Value Engineering Proposal

Function of Proposal: Increase substrate and habitat diversity of existing channel cross-sections and of channel structures (hardpoints, roundpoints) constructed in Schenimann Chute. As described in other proposals, woody structures could also be used to minimize erosion of existing caving banks that are contributing to the siltation of the chute.

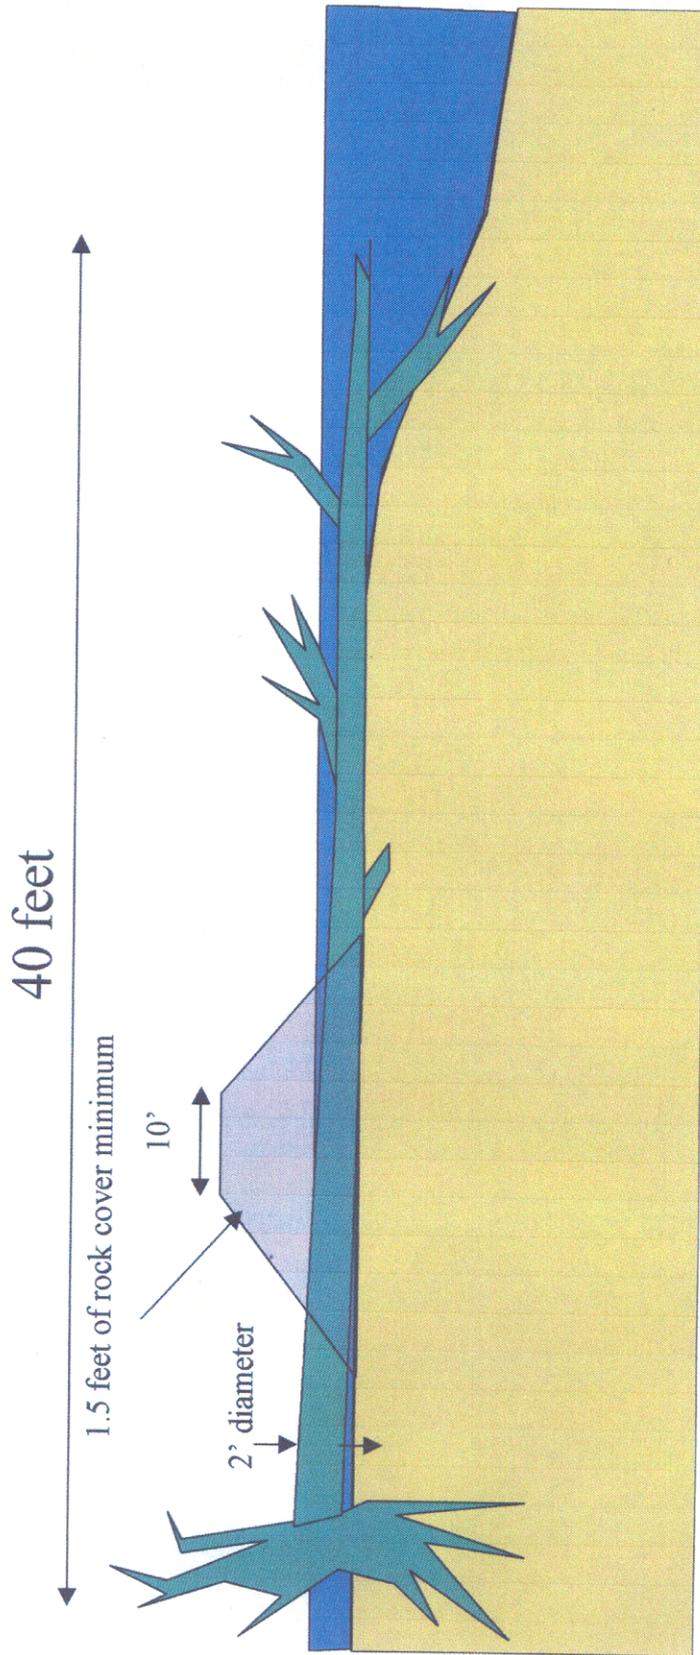
Proposed Change: Incorporate woody structures into different phases of the project. See accompanying figures. This could include:

- Selectively anchoring trees into pile dike no. 57.9 to change the flow distribution through this dike and increase scour at desired locations to maintain a continuous low flow channel.
- Incorporating trees into rock structures such as existing hardpoints or roundpoints
- Replacing revetment with trees (see proposal to replace rock revetment with trees).
- Anchoring trees within the chute at desired locations to increase diversity. Trees could be anchored using cables and anchors by placing rock on top of the trees or by placing geotubes on top of the tree.
